Consultation report of the Public consultation on the scenario's, sensitivities and data for the CRM parameter calculation for the Y-4 Auction with Delivery Period 2027-28

June 2022

Figure 1: Proposed trajectory for onshore wind

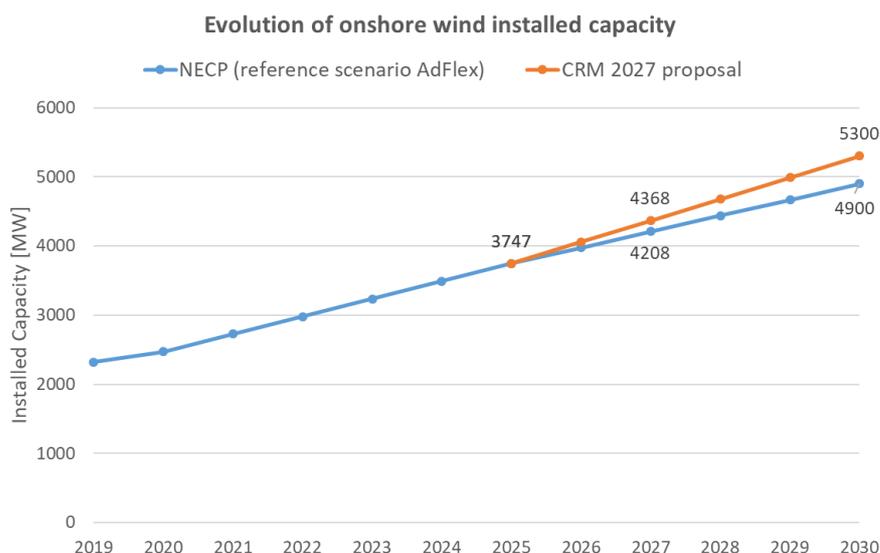
and should be considered in the base-case.
FEBELIEC	For renewables, as only aggregated numbers are given without any explanation, it is impossible to provide any meaningful information (e.g. applied annual growth rates by Elia are missing as well as the starting points on which to apply such growth rates). It is also very unclear which are the “latest developments” that are taken into account (and which cut-off date for updates was chosen).

On Figure 1 and Figure 2, Elia provides additional insights regarding the trajectories used to define the values for onshore wind and solar.

Regarding onshore wind, as we did not get any updated values from national public sources, the values for 2030 were deducted from the MIX scenario of the European Commission impact assessment of Fit For 55²³, assuming that an acceleration of the installation rate of the technology would happen from 2025 (Figure 1). It is therefore assumed that the necessary political decisions will be taken in order to unlock the potential of onshore wind in the future (e.g. Pax Eolenica from Wallonia²⁴) as required by the proposed plans at European level.

Figure 3: Proposed trajectory for small scale batteries

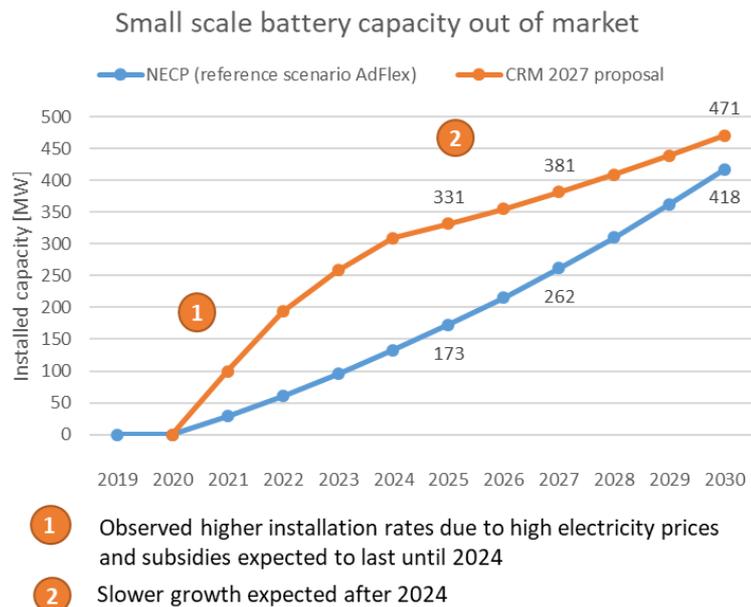
<p>being smartly charged).</p> <p>FEBEG has strong doubts that the deployment of smart/bi-directional charges will be generally available by 2027 as it is unlikely that the chargers that will be deployed with the increasing amount of electrical cars will be bi-directional or will be replaced by bi-directional chargers by 2027 (note that V2G charging infrastructure is also more expensive than normal “smart” charging infrastructure). Next to the availability/compatibility issue, it should be noted that the (financial) added value for the consumer remains very marginal and will probably not be impacting enough to drive a behavioral change.</p> <p>Considering all the above uncertainties and hurdles, we think the figure of 242MW of V2G by 2027 is overly optimistic.</p>
FEBELIEC	<p>For storage no full methodology is available describing volume determination for e.g. small scale storage, making it impossible to provide any meaningful comments to the proposed data. The same applies for the lack of reasoning explaining the proposed growth paths.</p>

Elia agrees with Febeg in its comment that the evolution of the installed capacity of batteries is highly dependent on the correct regulatory and technological framework. In this dataset, it is assumed that a CRM is in place and can secure a part of the batteries revenues.

The methodology for volume determination is explained in the Adequacy and Flexibility study.

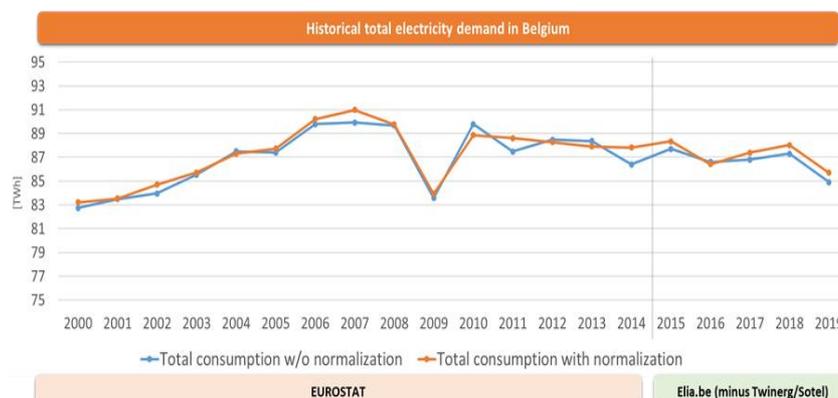
o On demand, Febeliec most strongly opposes the number provided by Elia as it is based on the projections of the Federal Planning Bureau of June 2021, predating the price increases which started after the summer of 2021 as well as the massive impact of the Ukrainian war on both the starting point (total demand for 2022 will be lower than 2021) as well as the growth path, which already has been impacted by the ongoing war and on which the further impact could also be very significant in a negative way if this war and its impact on energy prices will be exerting its impact for a longer period, potentially up to years.

o Febeliec in this context wants to refer again to data that was provided by Elia on Belgian overall electricity demand in the period 2000-2019 (both non-normalised and normalised data), which was provided by Elia in 2020.

The historical data sources are indicated on the chart.
 For the normalization, Elia applies a simple linear method based on the equivalent HDD, 'jours ouvrés' and amount of days in the year (correction for leap years).
 The normalization methodology is currently under review at Elia and could lead to slight differences in the historical normalization values. It is also important to note that the data above were never normalized before 2010 and that the same impact is used for the whole horizon.
 In past studies other sources have been also used for historical data (ENTSOE.net for instance) where the same definition of consumption was used across all countries. Since the introduction of a common tool at ENTSO-E (since MAF2019), the consumption source for future studies will be the one published on the Elia.be website which represents an estimation of the 'total electricity consumption' of Belgium.

In order to answer Febeliec's remark, please note that Elia only mentioned a value in order to provide stakeholders with an order of magnitude of the impact of the assumptions considered. This consumption estimation was made on outdated economic data published by the Federal Planning Bureau and will be updated with the latest available economic projections.

Figure 3: Price trajectories from European Commission document on price trajectories between 2020 and 2050 for gas, oil and coal³²

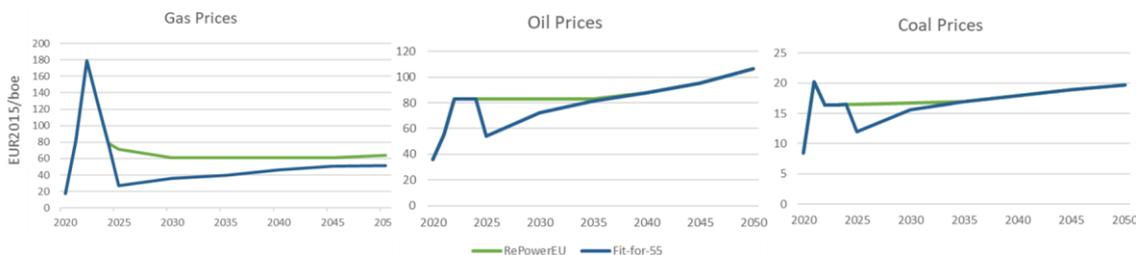
In order to avoid discussions on the best methodology to be used, an alternative proposal could be to use price trajectories from a recent European Commission document on fuel price trajectories between 2020 and 2050 for gas, oil and coal³¹ (see Figure 3).

The methodology used by the European Commission is in line with the proposed approach of Elia in the public consultation but the price levels themselves differ. Figure 4 presents the difference between the base scenario and 2 sensitivities proposed by Elia and the value set in the EC document.

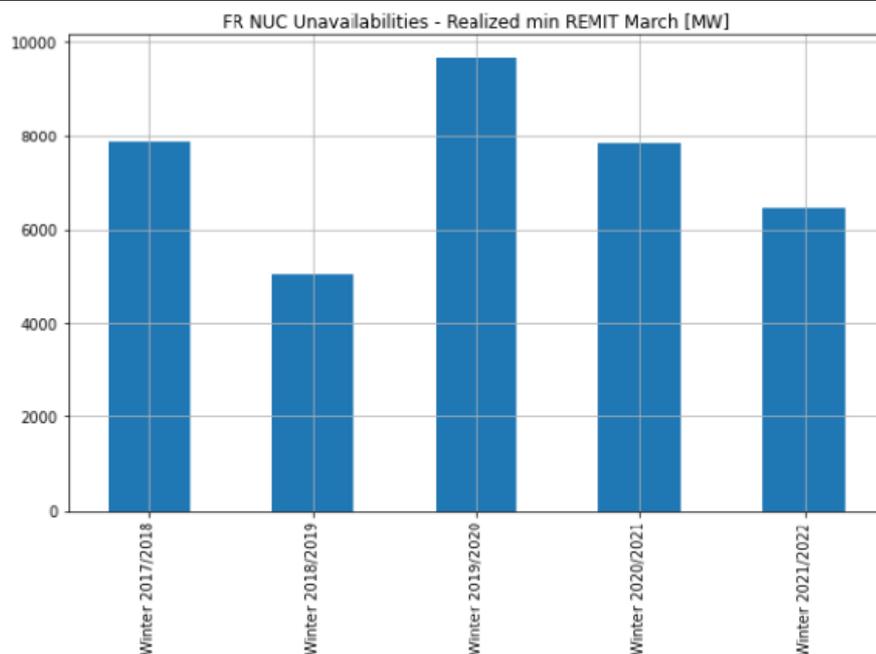
Engie	<p>Lower availability of the French nuclear availability based on historical values: according to ENGIE, based on the past performance of the French nuclear units and recent issues encountered by the French nuclear park, at least 8 units should be considered unavailable on average during a winter (on top of planned maintenances announced). Most adequacy studies, whether national or European, rely on modelling of power plants availabilities based on transparency platforms (REMIT obligations) declarations from operators. The French TSO (RTE) studies consider some drift, notably for the longest outages related to 10-year checks, but experience shows us that recurring “generic” issues have kept EDF from reaching the declared availability levels essentially every year in the recent past, whether due to steel defects, earthquake safety issues, pipe cracks or the impact of Covid on maintenance. The below graph shows that these unavailabilities are assessed on the basis of published shutdown forecasts for each nuclear unit. These unit-by-unit forecasts are always optimistic, with a lot of drift and almost never a shortening (except for work delays).</p>

What is shown for the past on the figure above is very likely to be repeated in the future: the guaranteed nuclear capacity, for every delivery year of the French capacity market, has always been lower than initially forecasted by EDF, with very low numbers expected in the next few years. EDF's reactors have historically produced more than 400 TWh per year, but the recent very low targets suggest a low availability for the coming years. In addition, we have observed, in the last months, announcements for the unavailability of plants during the same year or year to come (cf. press release 7/2/22: "*EDF ajuste son estimation de production nucléaire en France pour 2022*" and press release 11/02/22: "*EDF ajuste son estimation de production nucléaire en France pour 2023*"). Indeed, the recent issues faced by the nuclear parc in France linked to the corrosion checks on the nuclear reactors have a big impact on their future availability (at least in the short term but with no certainty for the medium term): currently there is 12 reactors stopped due to the abnormal corrosion phenomena, which affect the safety injection circuits (supposed to allow the injection of boron water to cool the reactor in case of a leak). The group EDF also said recently in the press it was "adjusting its nuclear production estimate for 2022 to 280-300 TWh from the previous 295-315 TWh announced in February 2022 (which was already a reduction from 300-330 TWh). At this stage, and pending the completion of checks and repairs, the nuclear production estimate for 2023, i.e. 300-330 TWh, is not modified"² but those units could be at risk in at least both 2023-2024 and possibly beyond. Given the impact that the capacity available (MW) in our neighboring countries has on

In the framework of the CRM calibration, Elia is only looking at what capacity would be available in France in the 2027-28 delivery period. This capacity is based on the data and assumptions provided by RTE in the dataset of the European Resource & Adequacy Assessment 2021, as presented in the explanatory note, in line with article 3, §2 of the Royal Decree.

This sensitivity on the nuclear availability in France is proposed in order for the Belgian authorities to cover themselves against lower nuclear availabilities in France compared to ERAA21. Such reasoning is compliant as it is justified and quantified as described in the explanatory note, in line with article 3, §4 of the Royal Decree.

Figure 6: CAPEX for batteries based on NREL ⁴⁴

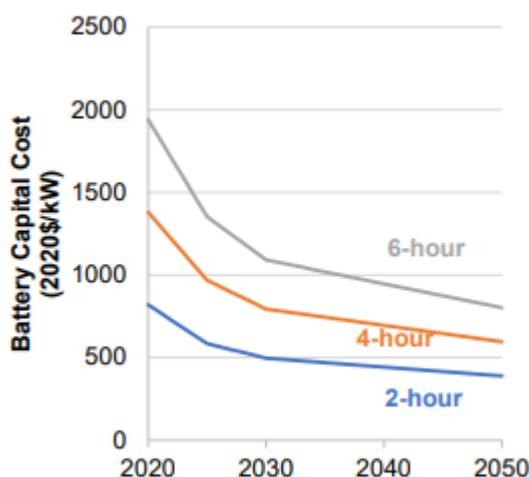
FEBEG	<p>As mentioned last year, it is questionable whether IC engines are relevant technologies to ensure the long-term adequacy in Belgium in (i) a European green deal context and (ii) a context where the additional capacity to ensure the security of supply is expected to replace baseload capacity.</p> <p>While we welcome the increase of CAPEX for batteries, we still consider that the used value are at the lower end (a figure of 400€/kW seems to be a good ballpark value).</p>
-------	--

Regarding batteries, based on available literature and feedback received, Elia proposes to update the values for batteries by 1) splitting large-scale batteries between the one with 1h energy content, 2h energy content and 4h energy content and 2) update the CAPEX according to Figure 6. The economic for batteries are summarized on Table 2. Finally, Elia proposes to only consider 1 single large-scale batteries category for the preselected capacity types. The most relevant choice according to Elia would then to consider 4h energy content batteries as this is the category with the highest share foreseen (see §3.2.6).

Large-scale batteries	CAPEX [€/kW]	FOM [€/kW/y]	Economic lifetime [y]
1h energy content	250	15	15
2h energy content	400	15	15
4h energy content	750	15	15
